RE: New Bedford Harbor State Enhanced Remedy

Modifications to 2008 and 2012 TSCA 40 CFR Section 761.61(c) Determinations to Allow Disposal of Federal Channel Dredged Sediments

INTERIM FEDERAL CHANNEL DREDGING PROPOSED CONDITIONS

ATTACHMENT 1 PAGE 1 OF 5

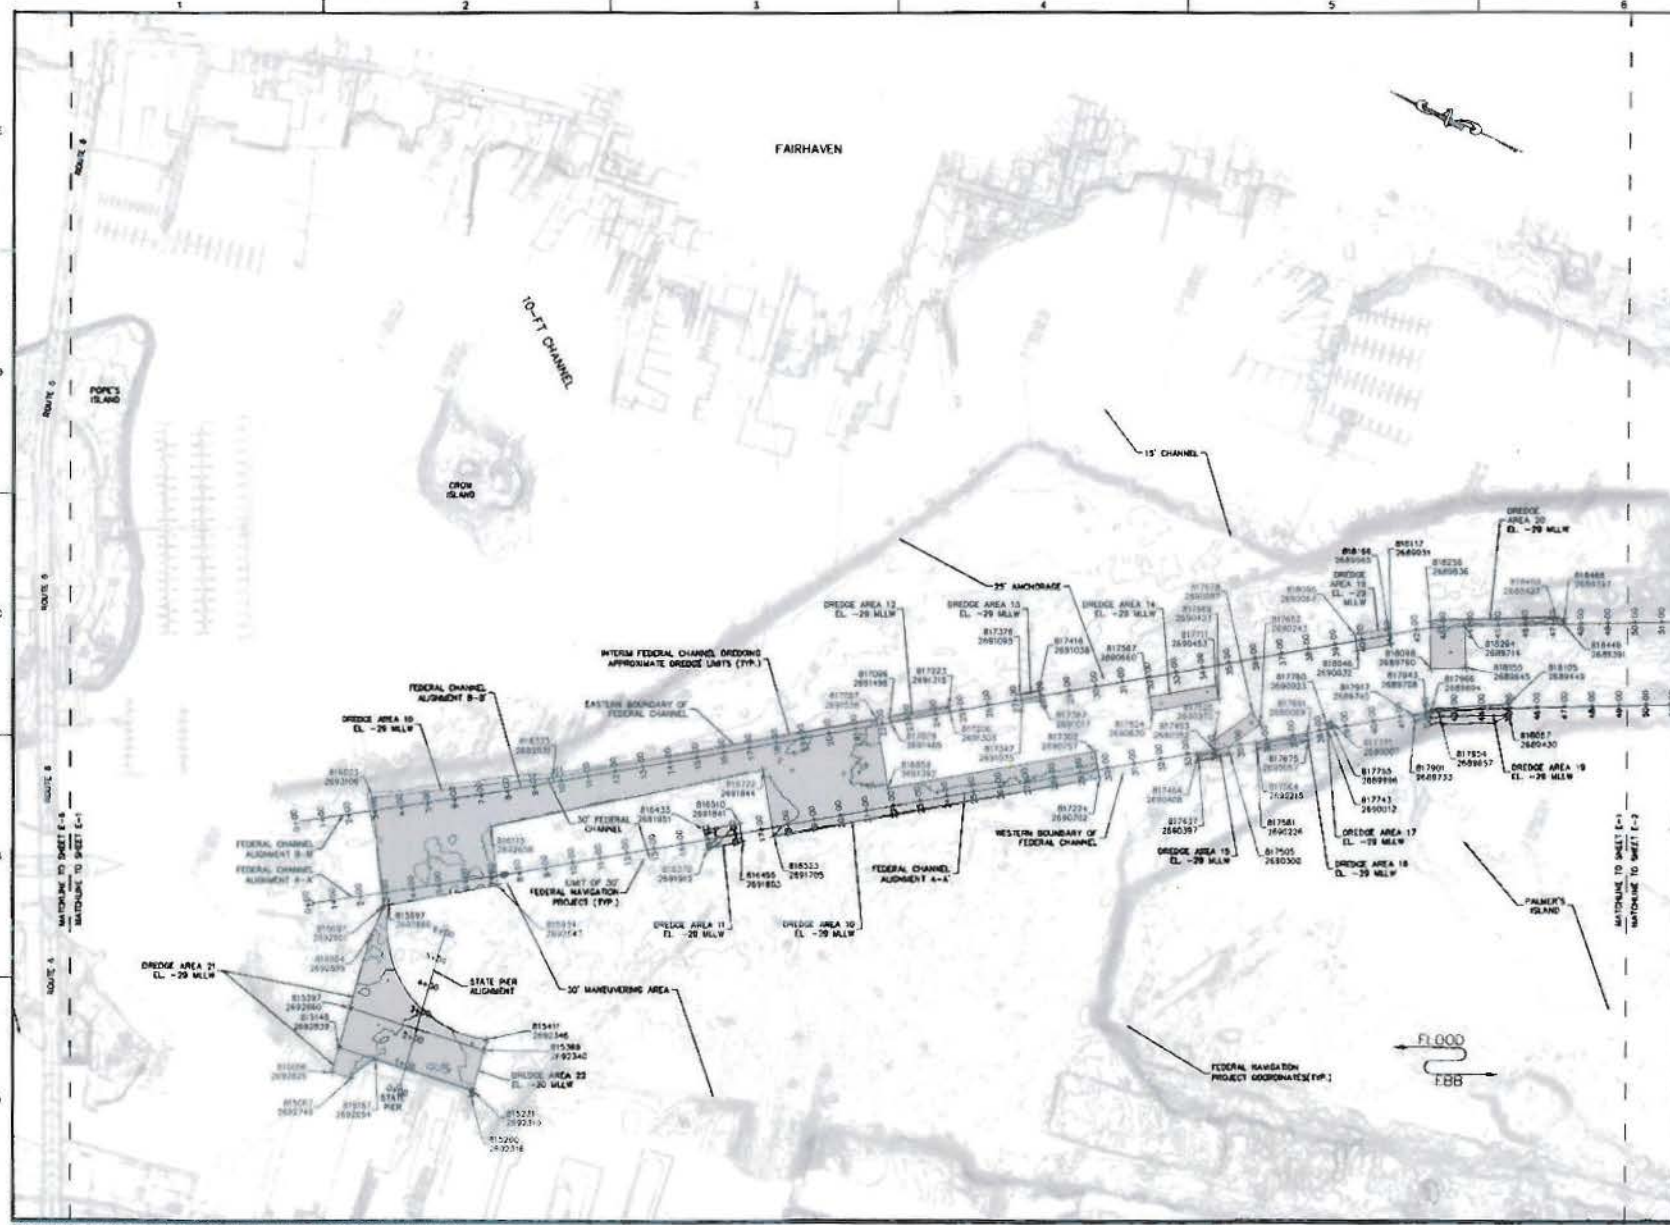
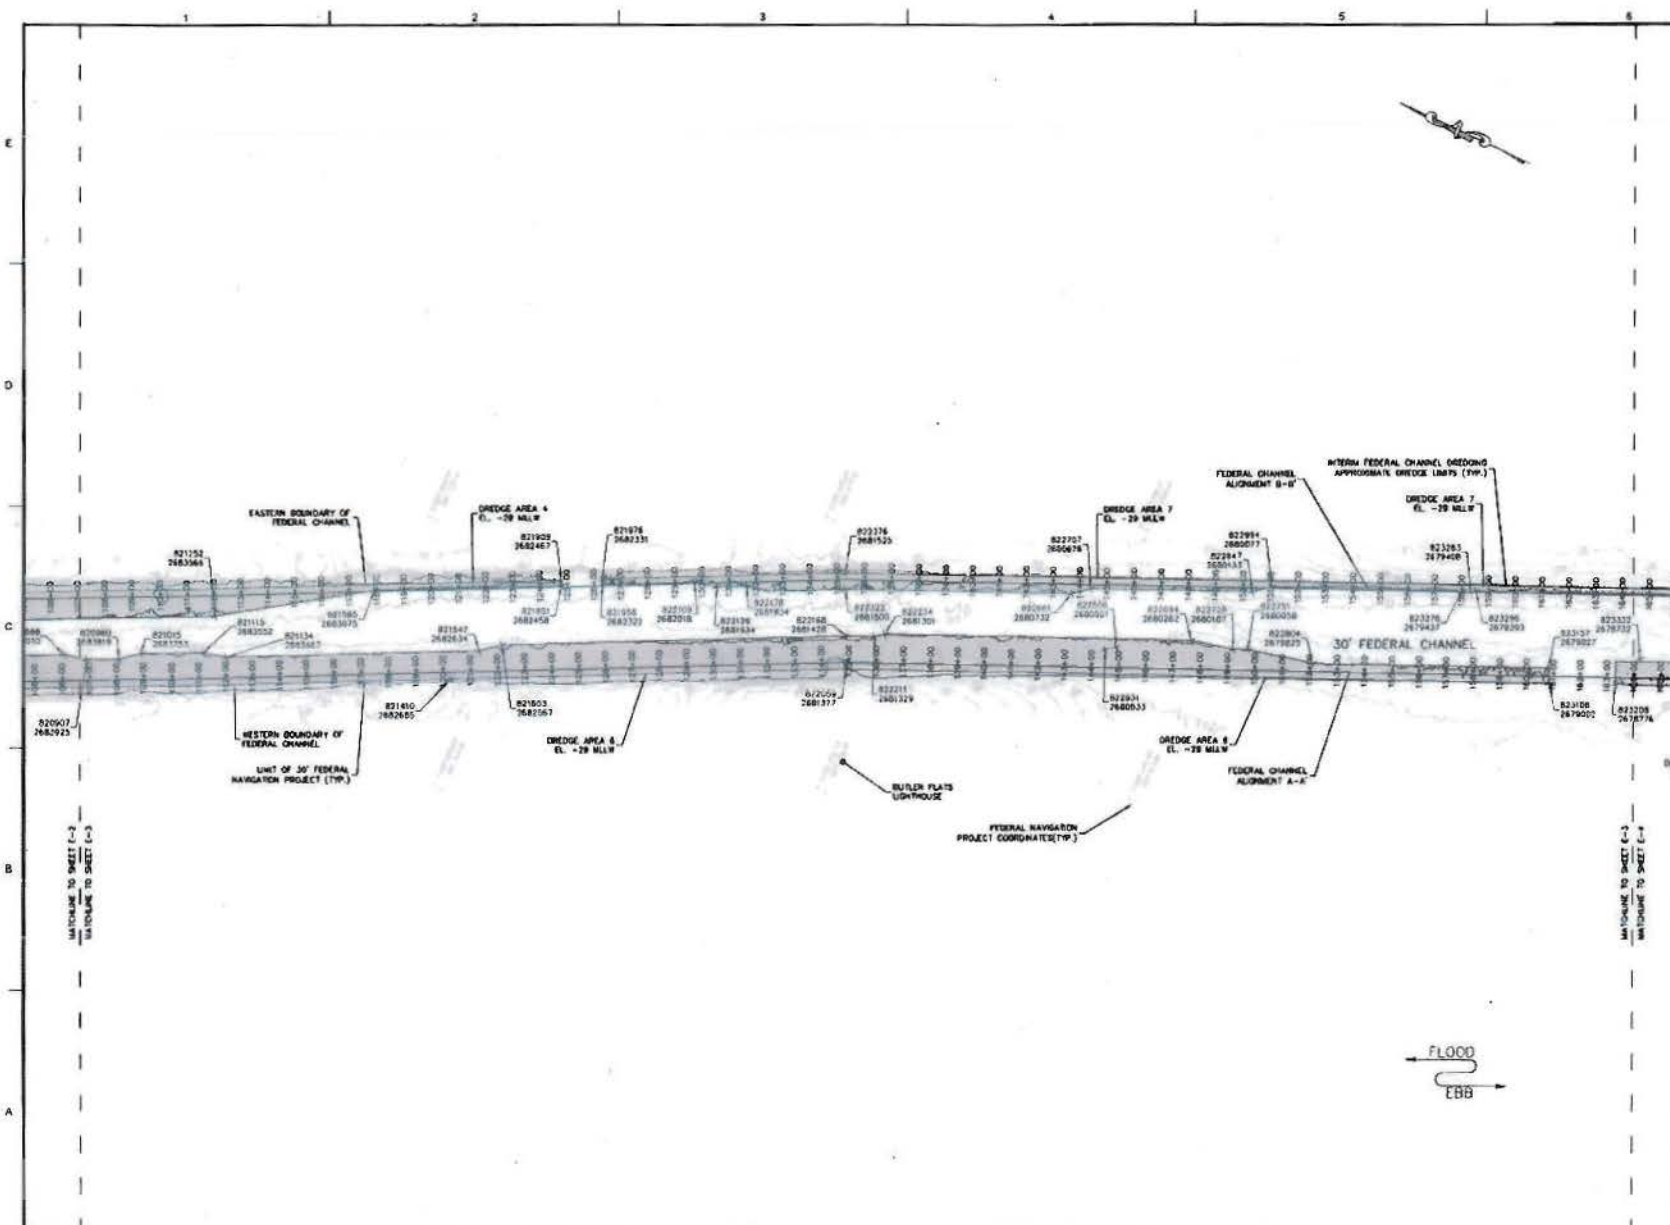
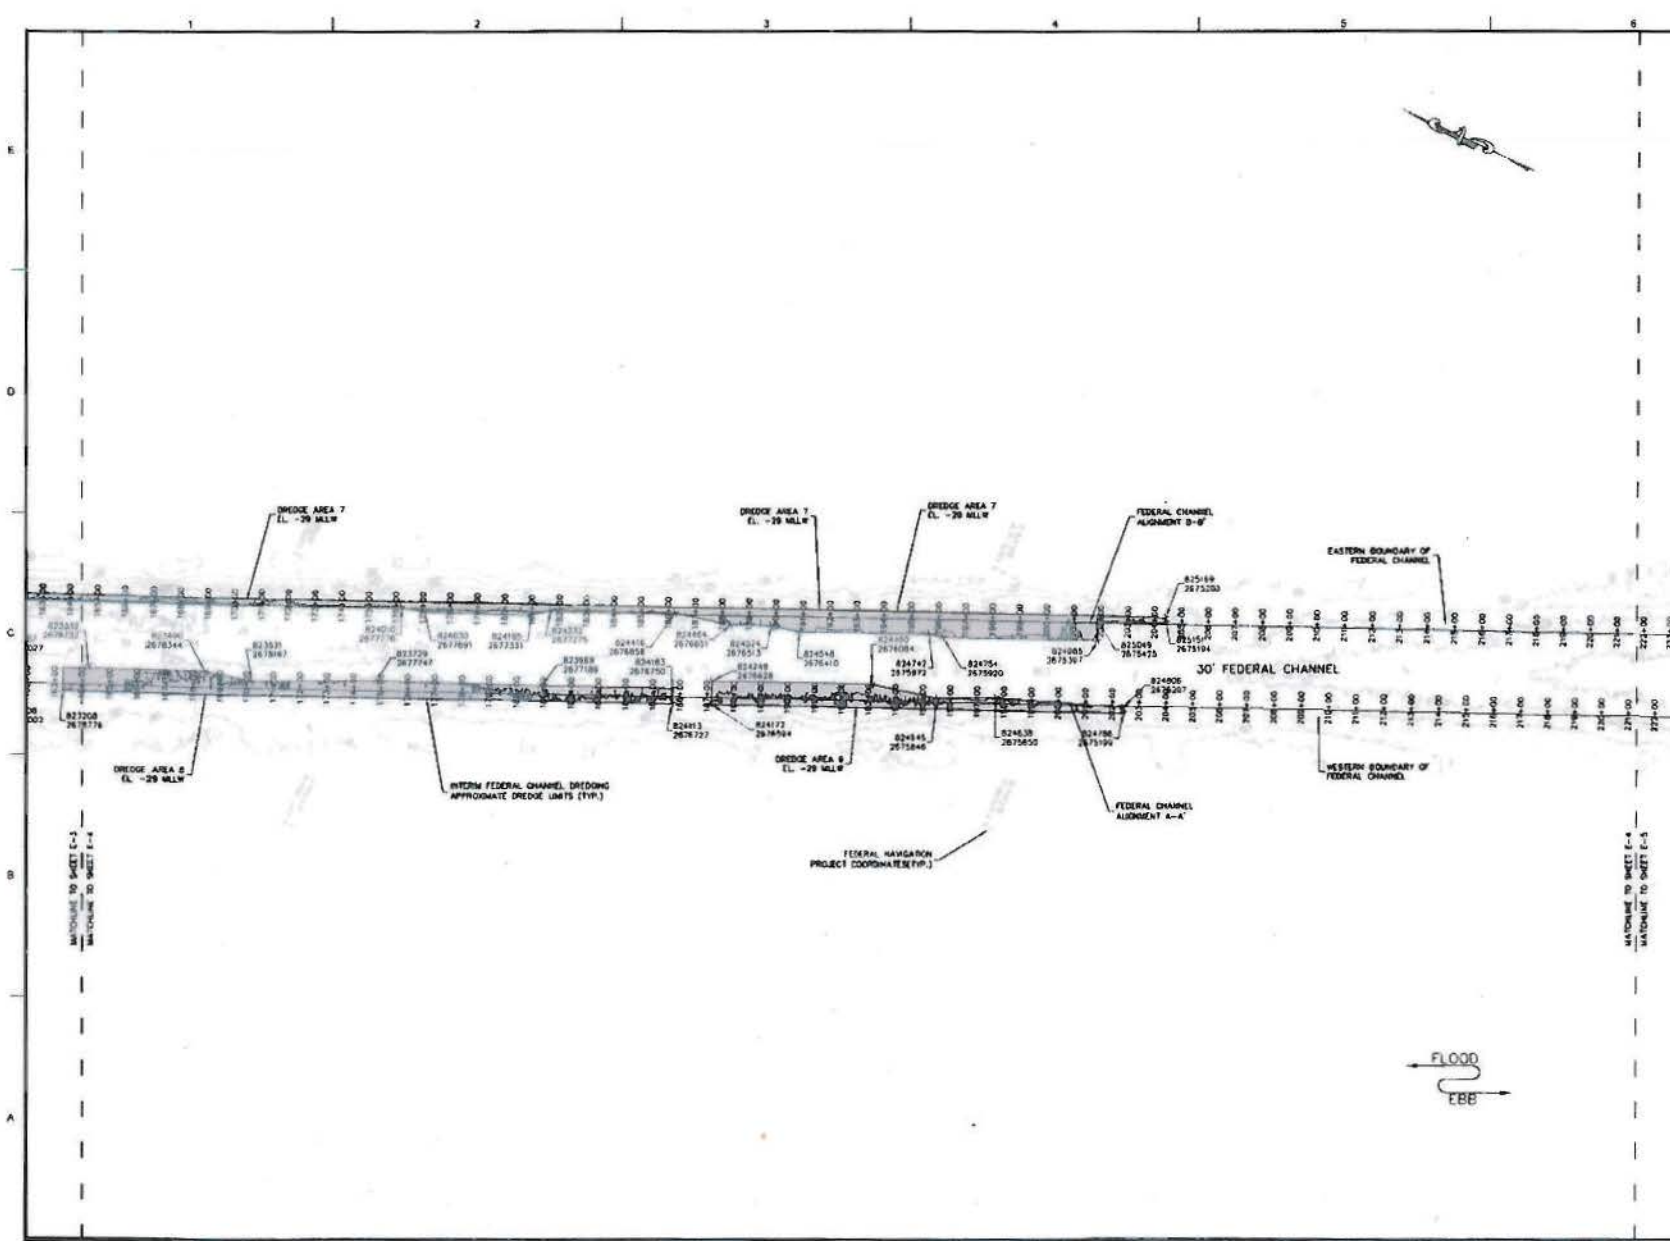
4. Areas 21 and 22 as shown on Attachment 1 are not authorized for excavation and disposal in either CAD cell #2 or #3 under this TSCA Determination as insufficient *in situ* PCB sampling data exists to support that PCB concentrations are less than (“<”) 50 ppm. In the event that the Commonwealth provides PCB data to EPA confirming PCB concentrations are < 50 ppm within Areas 21 and 22, these PCB-contaminated sediments may be excavated and disposed within CAD cell #2 and/or CAD cell #3 in accordance with the conditions set out in this TSCA Determination.

This TSCA Determination is based on the information contained in Attachment 2 and is limited to the proposed excavation areas as shown in Attachment 1, except as provided in the conditions specified above.
